HILLIARD PLANNING AND ZONING BOARD MEETING

SUBJECT: Planning and Zoning Board approval of Site Plan Application No. 20240131. Parcel #16-3N-24-0000-0024-0070. Applicant: Karen Brantley, Florida Infrastructure.

Site Plan Application 20240131 Florida Infs.
Review Report

RE: Determination of Completeness and Site Plan Review
Florida Infrastructure Truck Shop
Town of Hilliard, Florida
Mittauer & Associates, Inc. Project No. 9610-23-26

C5.0
 PROJECT NUMBER
 2023-1216

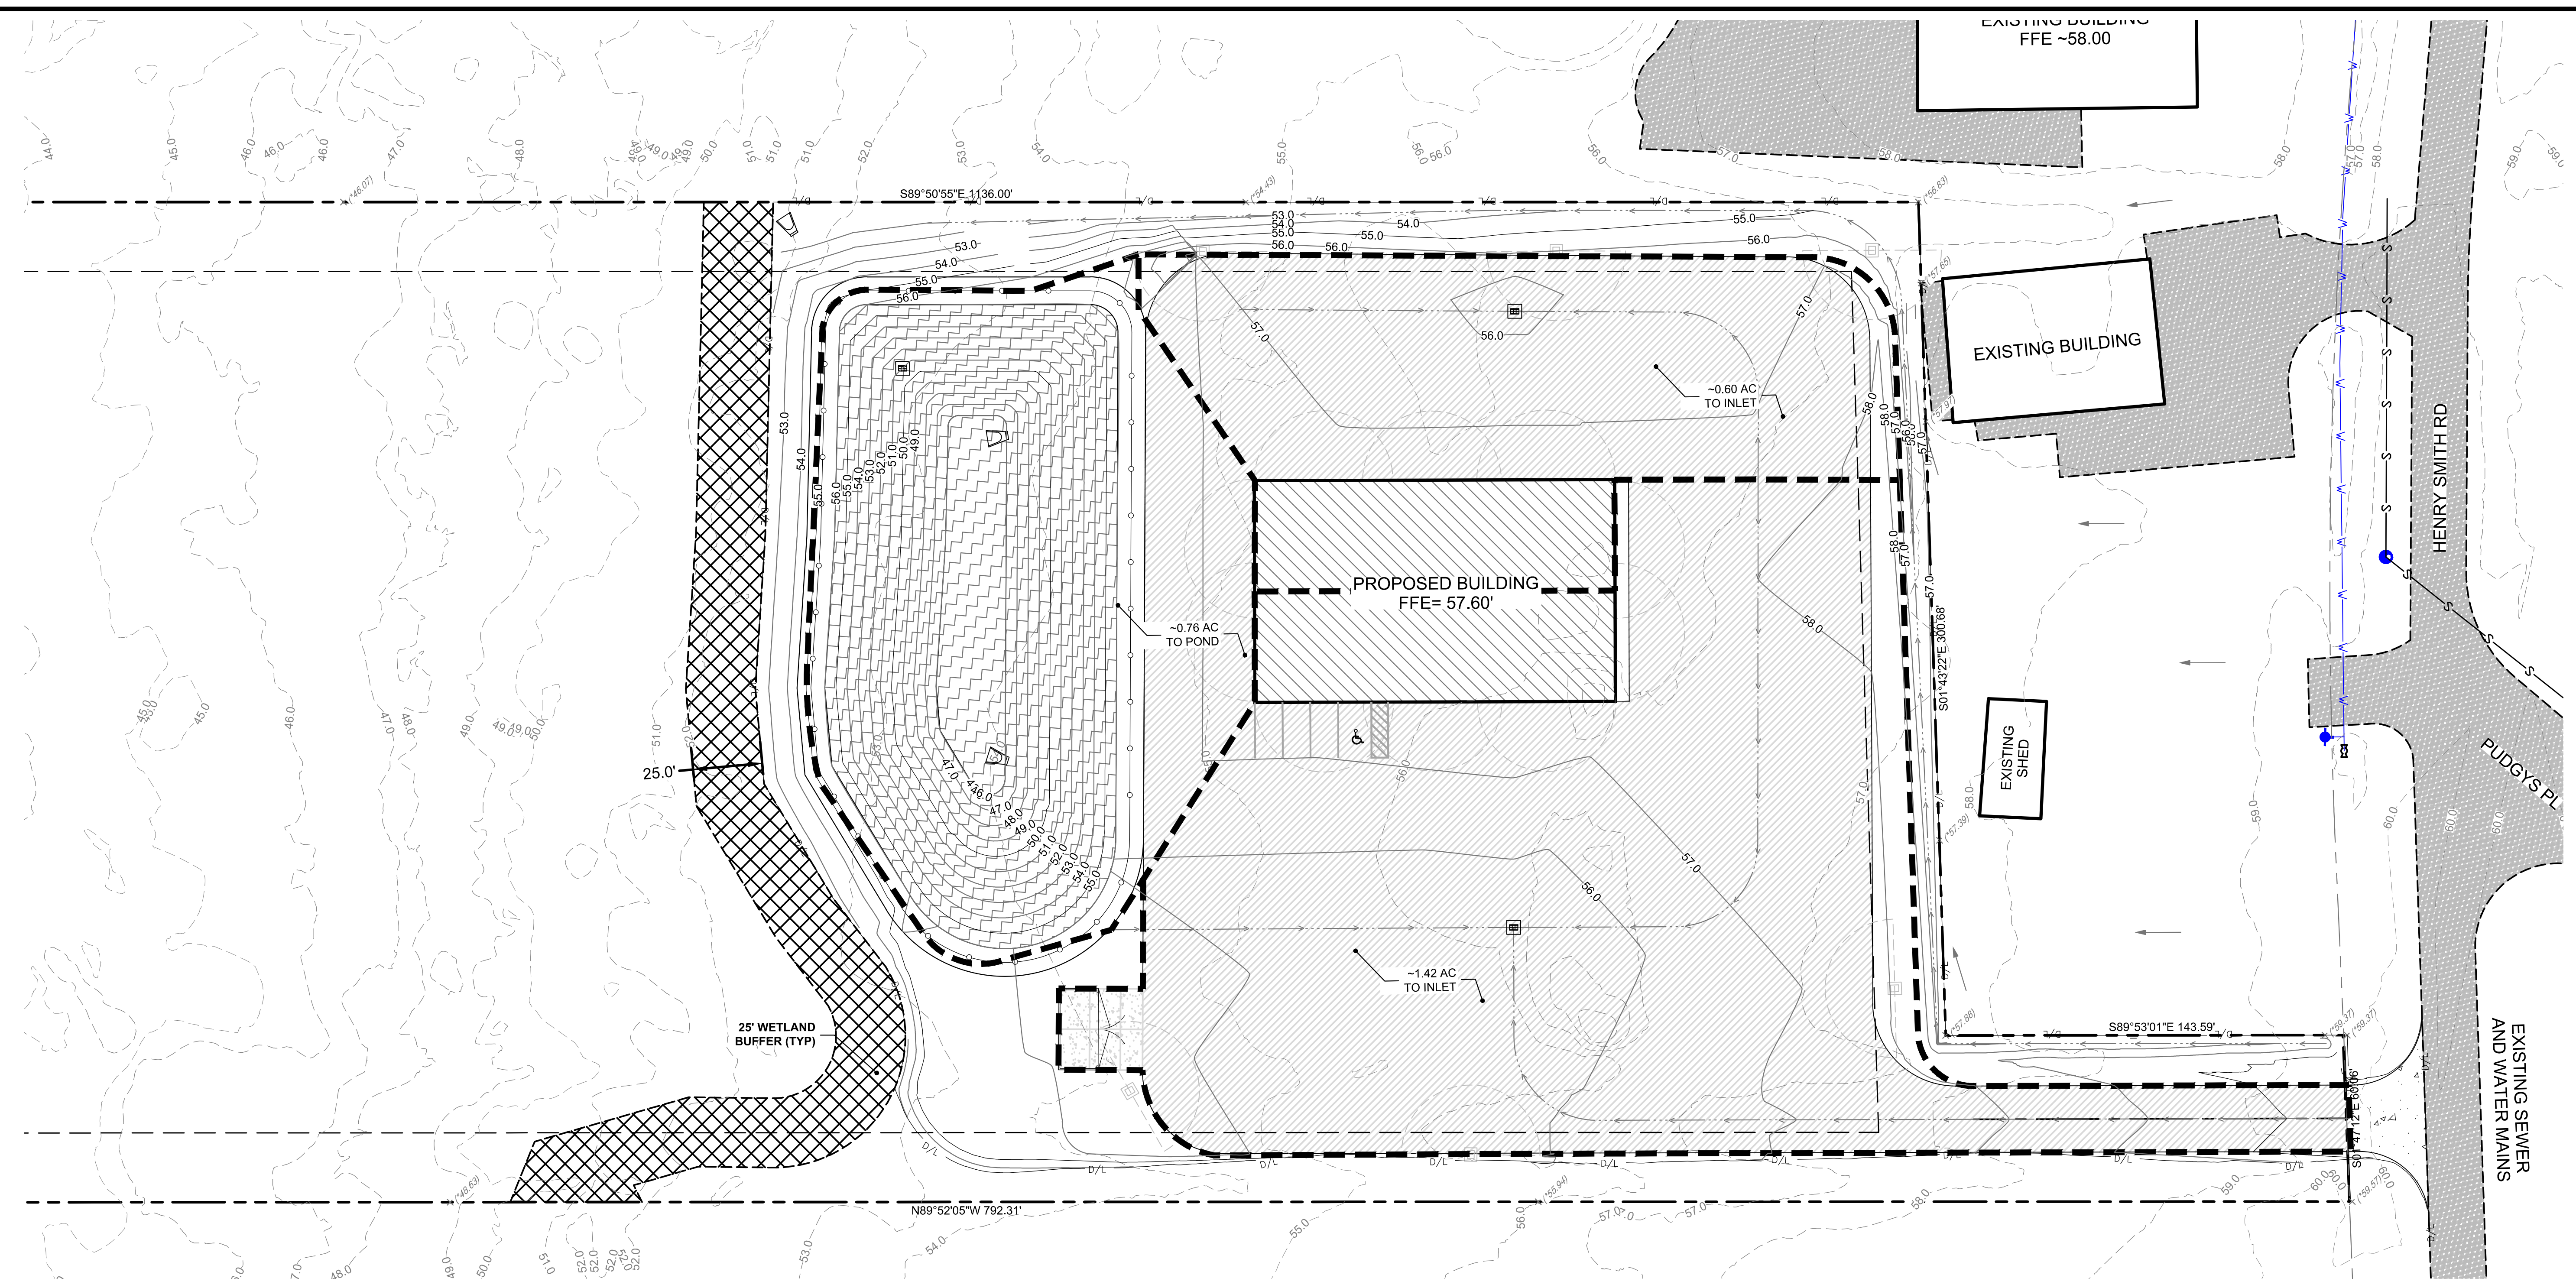
SHEET C5.0 - DRAINAGE PLAN

1. Along with Comment No. 1 for Sheet C4.0 above, coordinate with the Town to determine whether a driveway culvert and associated permit will be required. Verify whether an existing culvert is already located at this proposed entrance and address, as needed. Should a culvert be required, the diameter shall be a minimum of 12" in accordance with Ordinance Section 42-31 through 42-34.

1. Along with Comment No. 1 for Sheet C4.0 above, coordinate with the Town to determine whether a driveway culvert and associated permit will be required. Verify whether an existing culvert is already located at this proposed entrance and address, as needed. Should a culvert be required, the diameter shall be a minimum of 12" in accordance with Ordinance Section 42-31 through 42-34.
Noted. Nassau County will decide the roadway design per their permitting requirements.

C5.1
 PROJECT NUMBER
 2023-1216

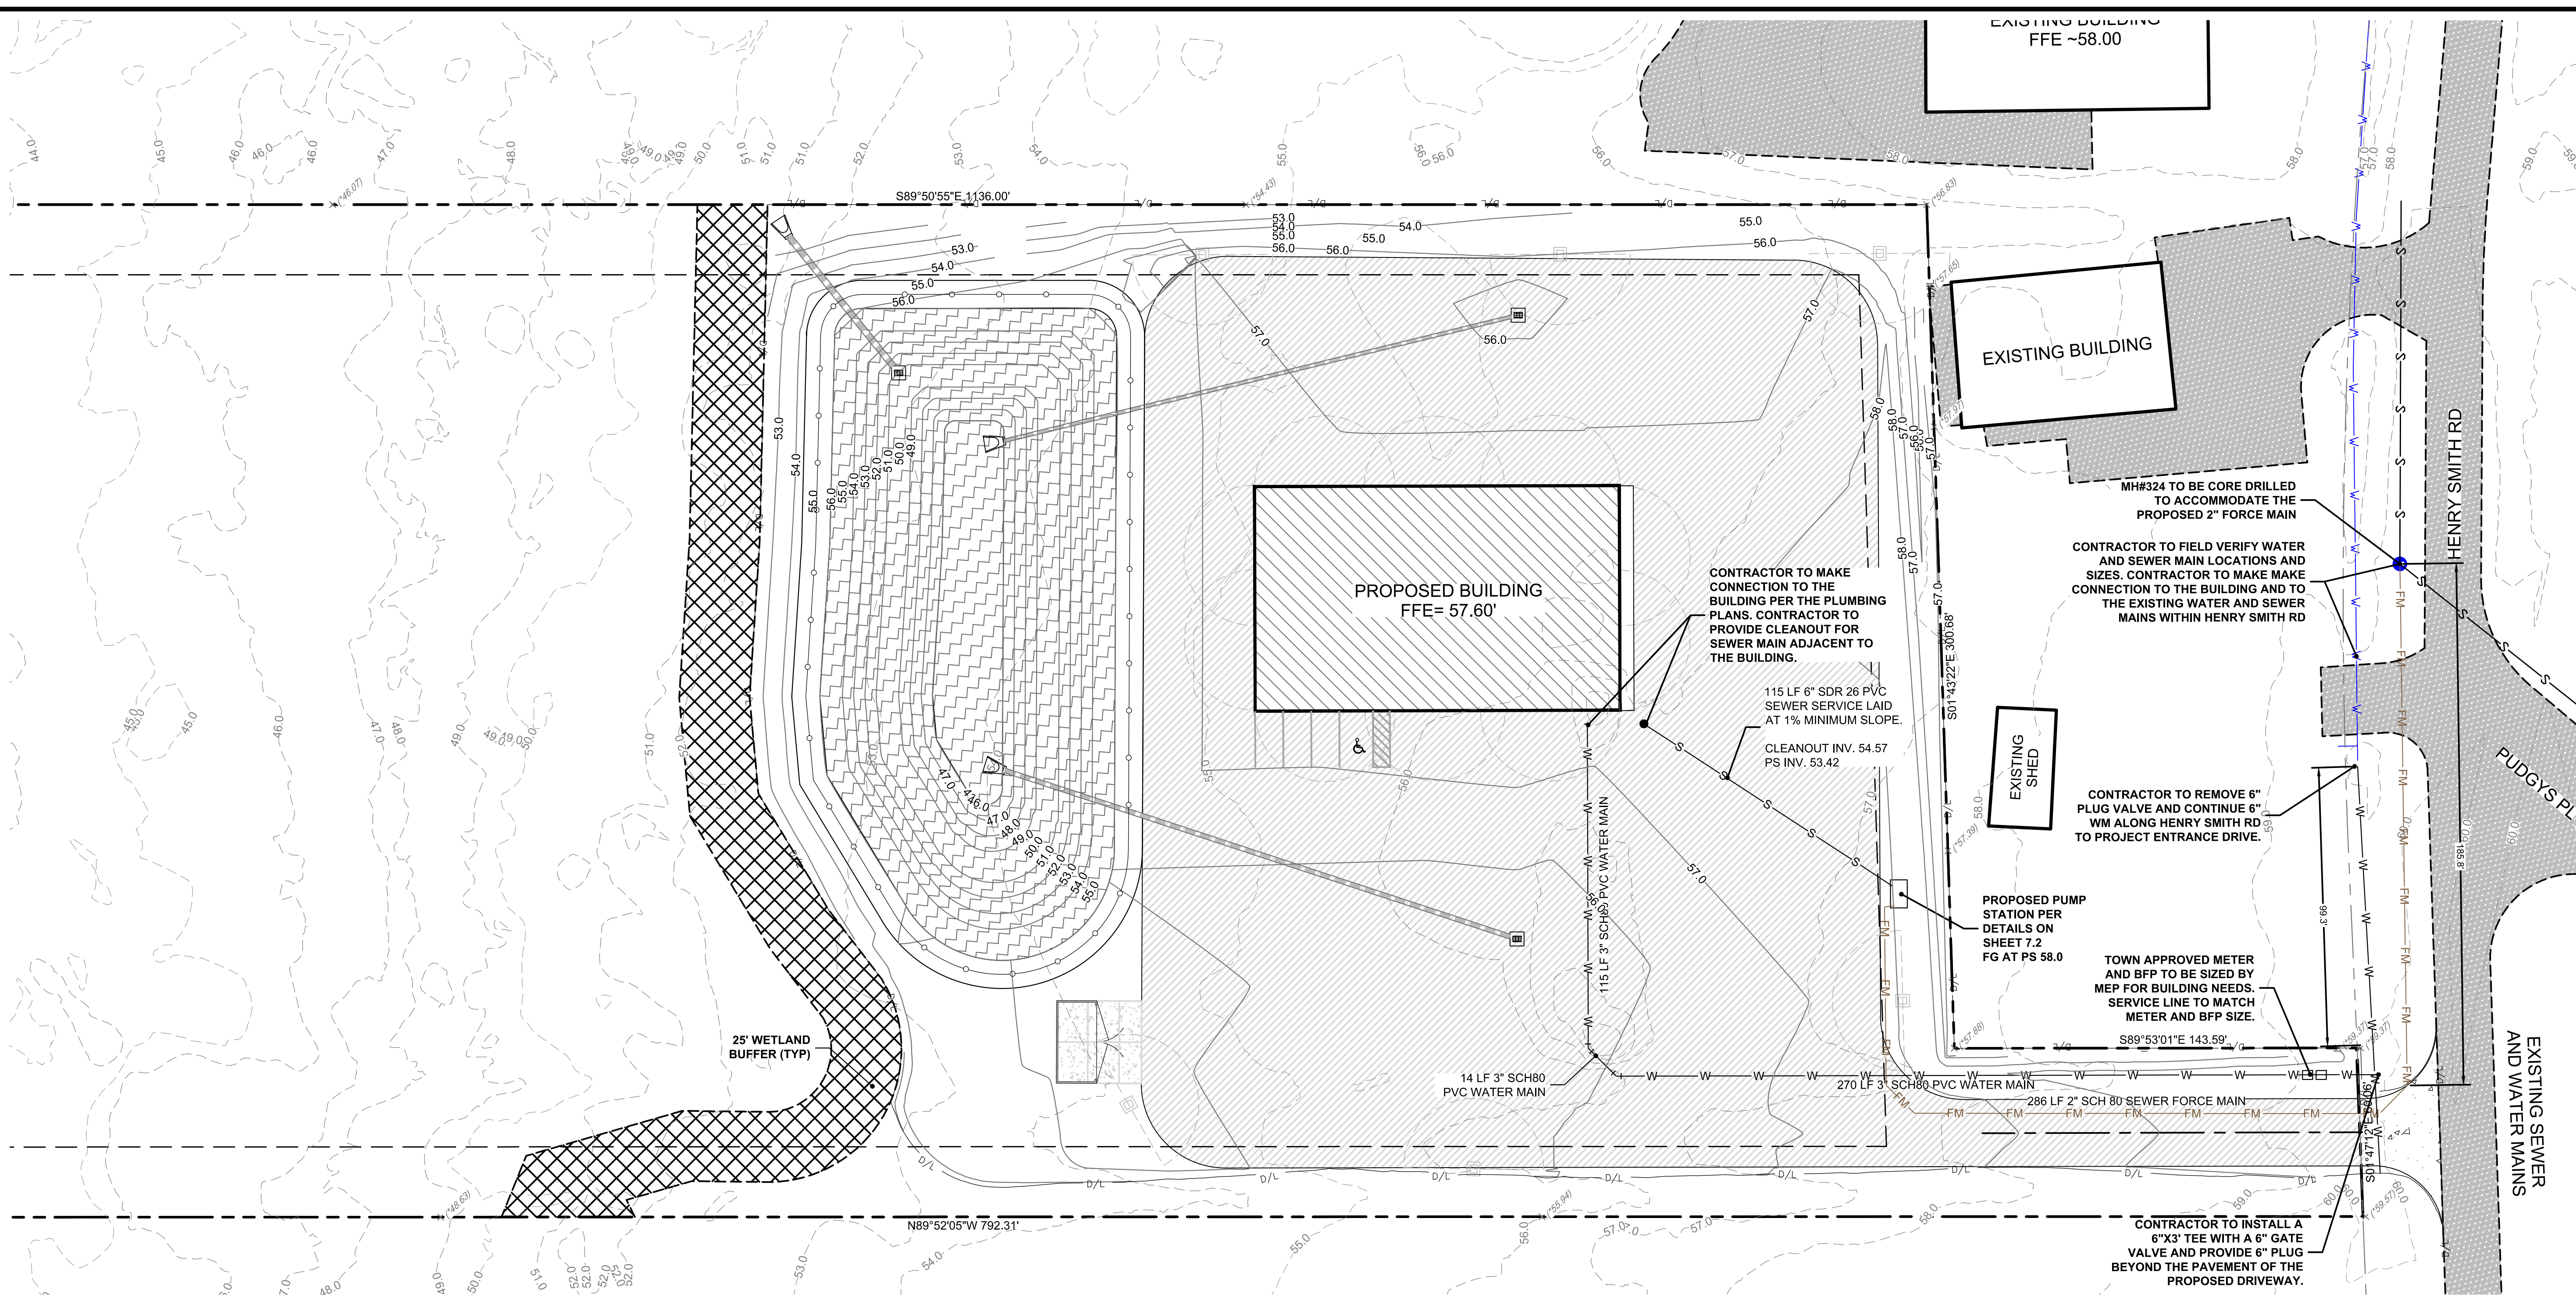
SHEET C5.2 - POST DEVELOPMENT PLAN

1. Clarify the purpose of this Sheet other than showing the boundaries of the post-development drainage areas. No other details are provided.

1. Clarify the purpose of this Sheet other than showing the boundaries of the post-development drainage areas. No other details are provided.
You are correct, the purpose is to define the boundaries of the post developed areas. The area of the drainage basins has been added to the plans. The sheet has been provided for the Water Management District.

C6.0
 PROJECT NUMBER
 2023-1216

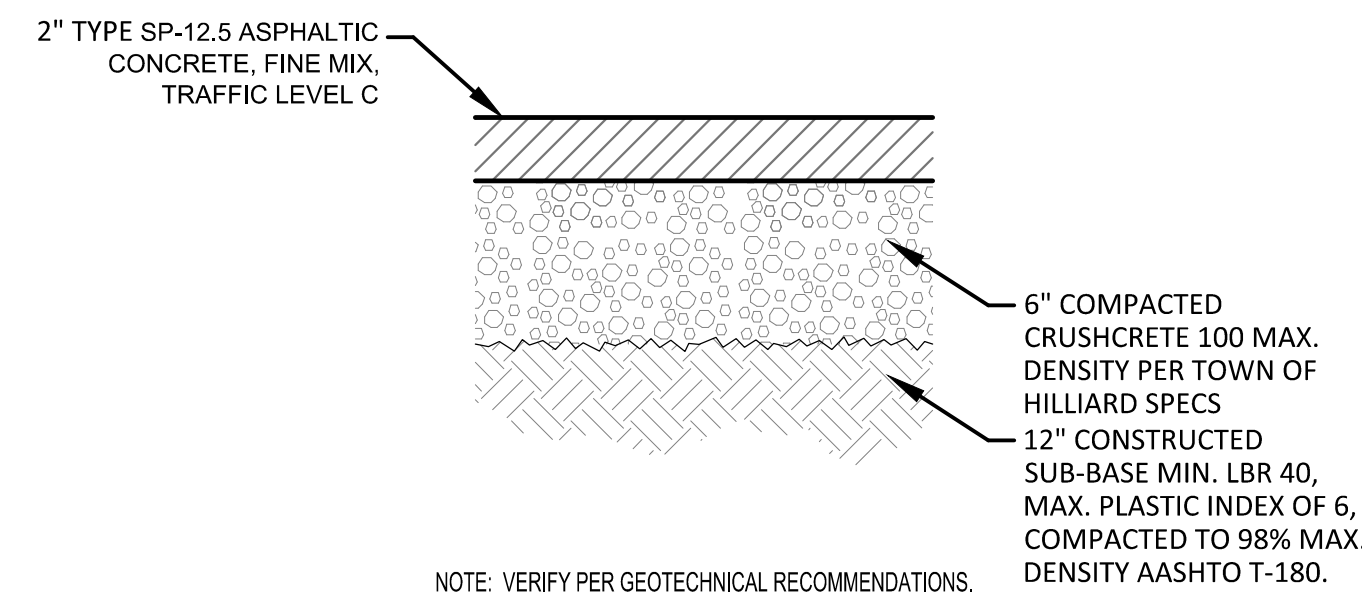
SHEET C6.0 - WATER & SEWER PLAN

1. Coordinate with the Town to verify the size, material, and location of the Town's existing water and sewer lines for the proposed connections.

2. Update the proposed this sheet to reflect the proposed offsite water and sewer utilities and associated connection points. For the water, we recommend removing the existing 6" plug and extending a 6" PVC water main south along Henry Smith Road

beyond the proposed driveway, installing a 6"x6"x4" Tee, along with a 6" gate valve and plug to allow for future connections / extensions. For the sewer, assuming it is not possible to connect to the existing manhole via gravity, we recommend constructing the PVC force main along Henry Smith Road north and core drilling into the existing manhole to connect to the gravity system. Include / show any necessary restoration associated with these offsite improvements.

3. No details for the proposed Pump Station are provided, including on Sheet C7.2 as indicated. Update / revise, as needed, and provide applicable flow and pump calculations.
4. Provide cleanout at building connection along with gravity sewer depth, elevations, and slope.
5. Call out location and size of water meter and backflow device on Town's side of right-of-way line.
6. Ensure adequate fire protection can be provided for the site in accordance with NFPA regulations / FDEP regulations. Recommend coordinating with the Town to conduct a hydrant flow test on the nearest hydrant to determine fire flow capability to the site.
7. Ensure proper electrical service and placement requirements will be met in accordance with the LDR.

1. Coordinate with the Town to verify the size, material, and location of the Town's existing water and sewer lines for the proposed connections.
Noted. Staff has provided sizes and approximate locations of water and sewer mains.
2. Based on the Town's Water System Base Map we have on file, there is an existing 6" PVC water main along the west side of Henry Smith Road which terminates with a 6" gate valve and plug, just beyond the fire hydrant assembly.
Noted.

4. Update the proposed utilities this sheet to reflect the proposed offsite water and sewer utilities and associated connection points. For the water, we recommend removing the existing 6" plug and extending a 6" PVC water main south along Henry Smith Road beyond the proposed driveway, installing a 6"x6"x3" Tee, along with a 6" gate valve and plug to allow for future connections / extensions. For the sewer, assuming it is not possible to connect to the existing manhole via gravity, we recommend constructing the PVC force main along Henry Smith Road north and core drilling into the existing manhole to connect to the gravity system. Include / show any necessary restoration associated with these offsite improvements.
Noted.

5. No details for the proposed Pump Station are provided, including on Sheet C7.2 as indicated. Update / revise, as needed, and provide applicable flow and pump calculations.
DH152-93 EOne model pump station details have been provided on C7.2. The assumed daily flow from the truck shop is derived from FDEP 64e-6, warehouse complete with 10 employees and 3 loading bays for a total of 450 GPD. The tank capacity is 150 gal.

6. Provide cleanout at building connection along with gravity sewer depth, elevations, and slope.
Cleanout added to plans along with details for 6" service at 1% minimum slope.

STD DUTY PAVEMENT SECTION

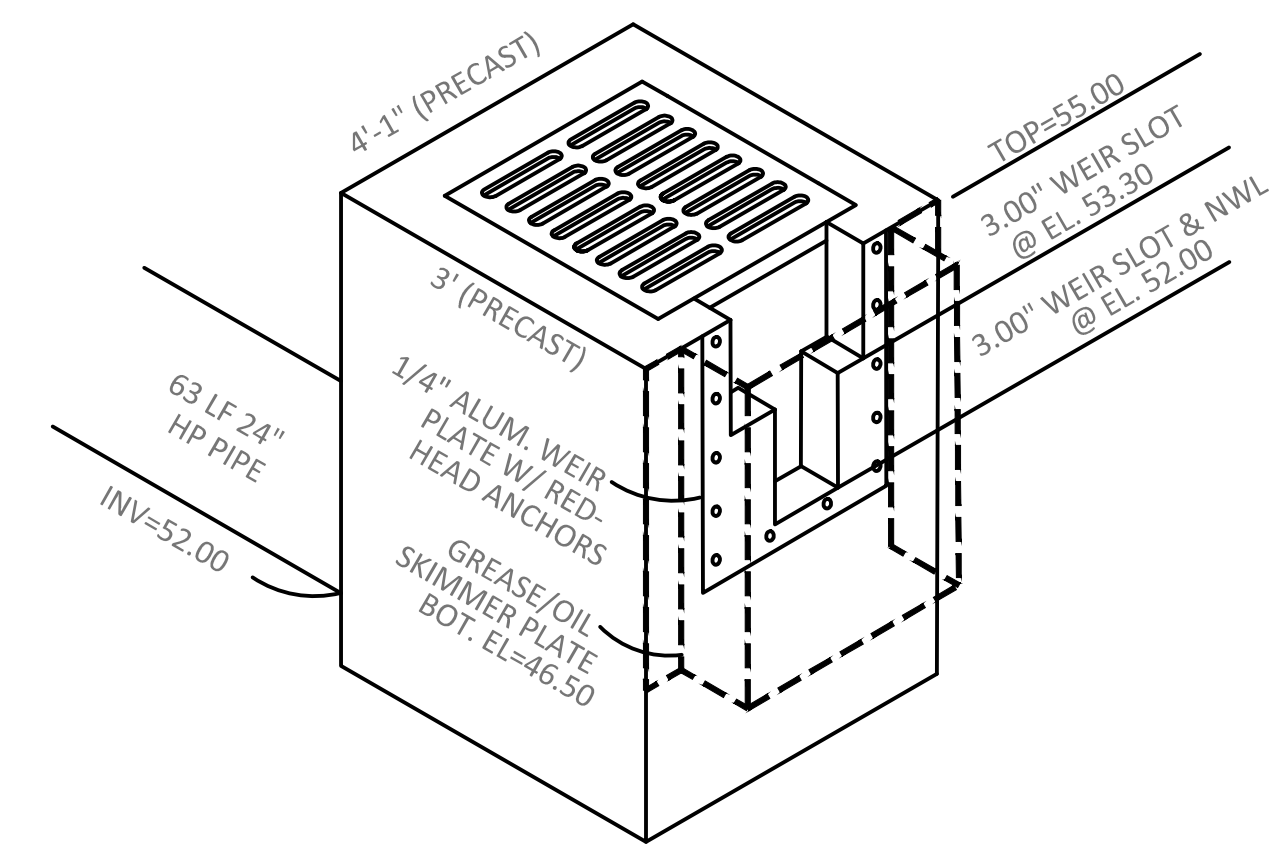
2. Recommend Asphaltic Concrete Driveway section match the Std Duty Pavement section above for consistency.
Asphaltic Concrete Driveway detail has been removed from the plan set.
